USB Power Delivery ENGINEERING CHANGE NOTICE

Title: Deprecate the GotoMin/GiveBack Features and Update Power Reserve

**Applied to: USB Power Delivery Specification Revision 3.2
Version 1.0**

Figure B-3 “Giving Back Power”

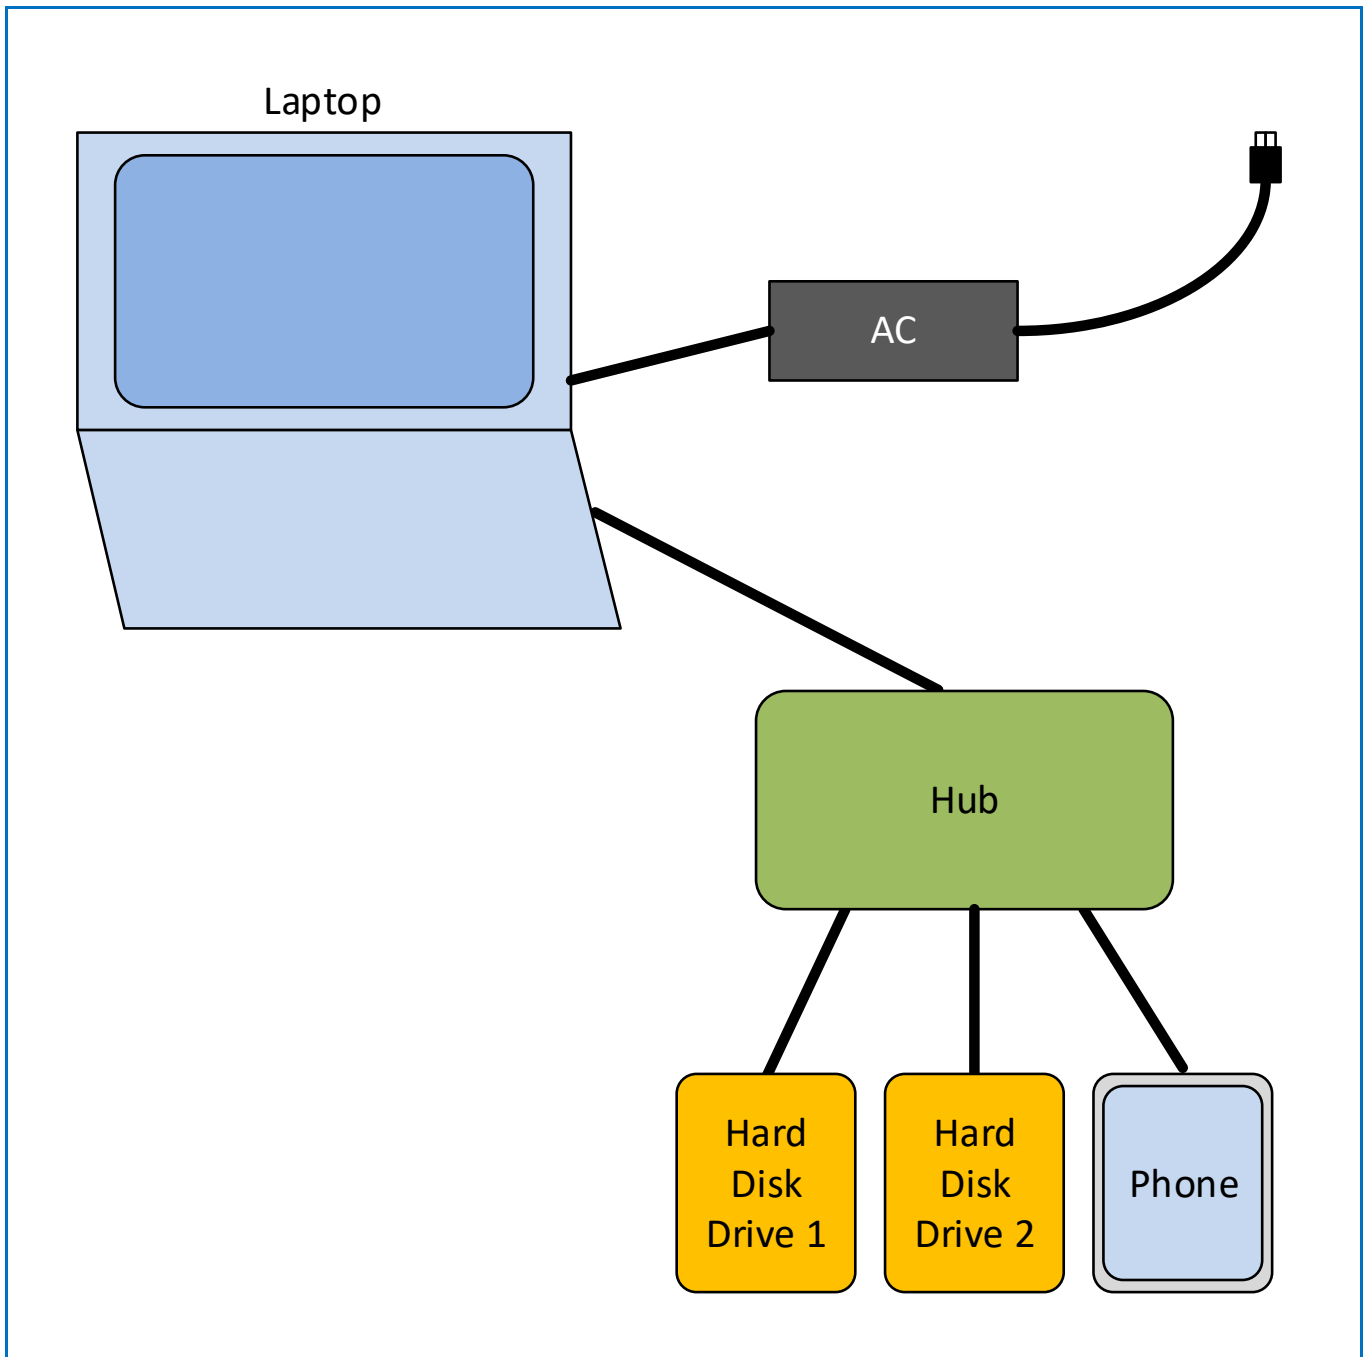
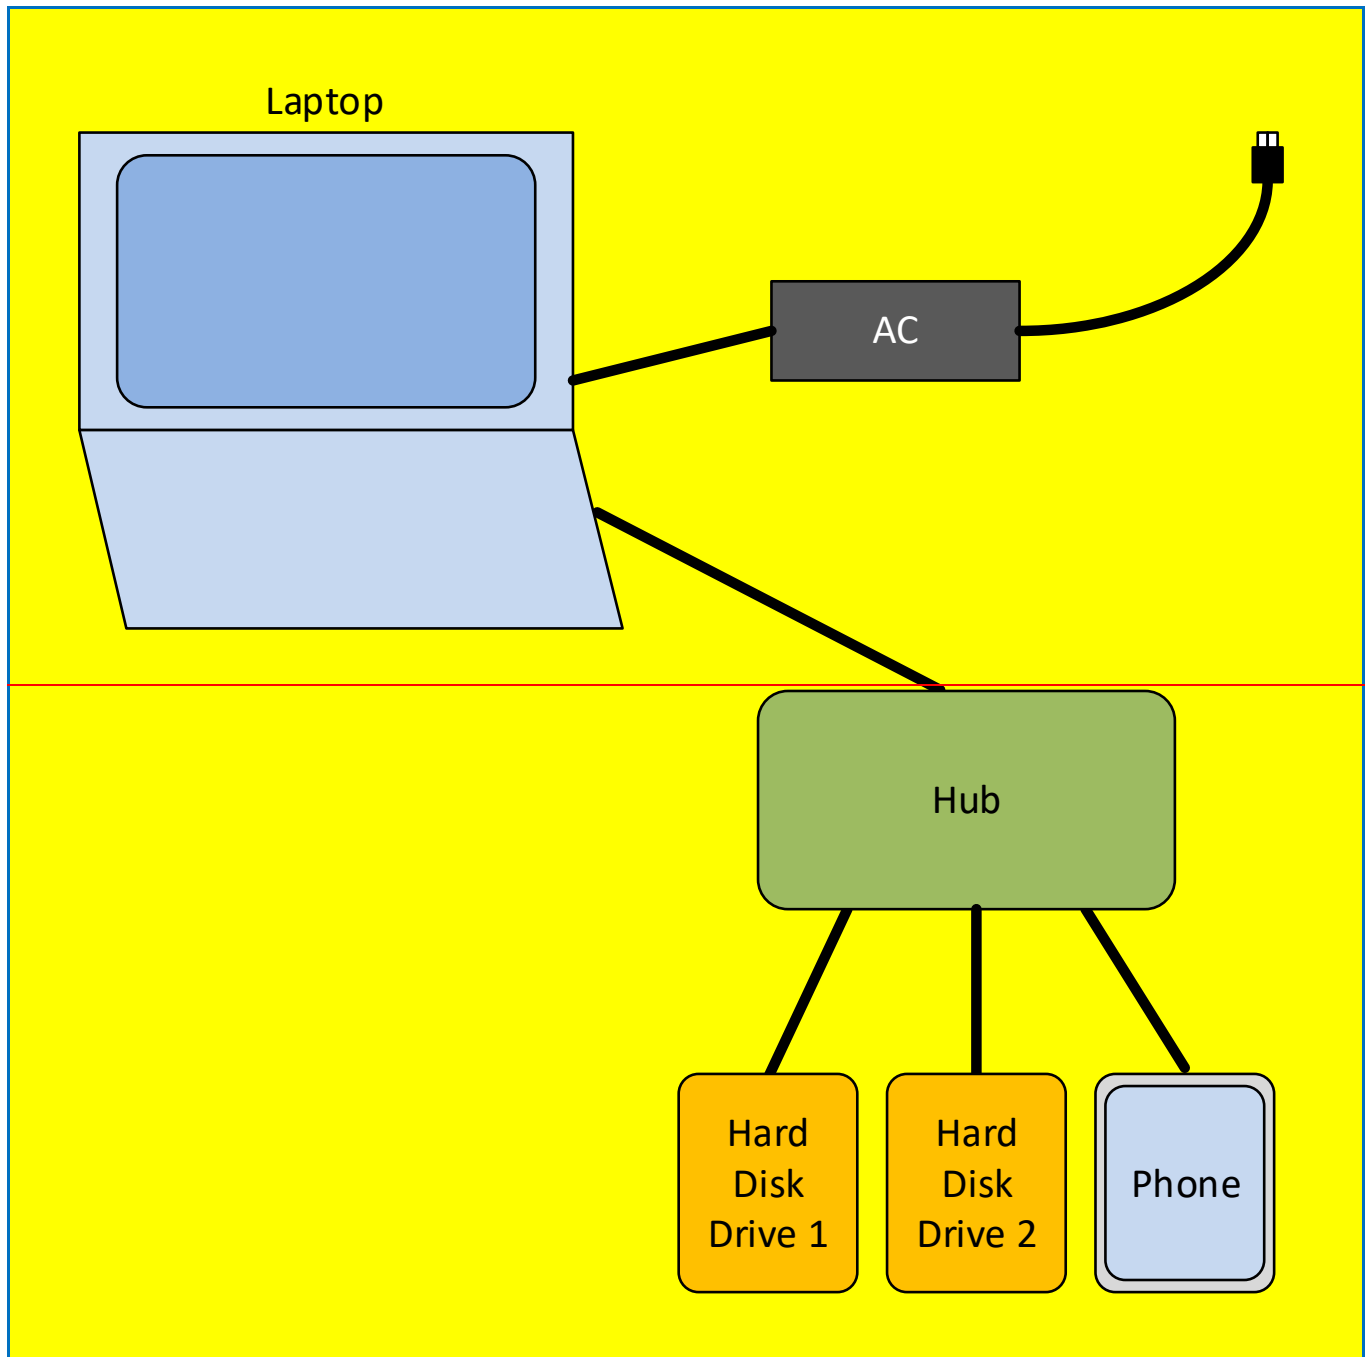
B.3 ~~Giving back power~~
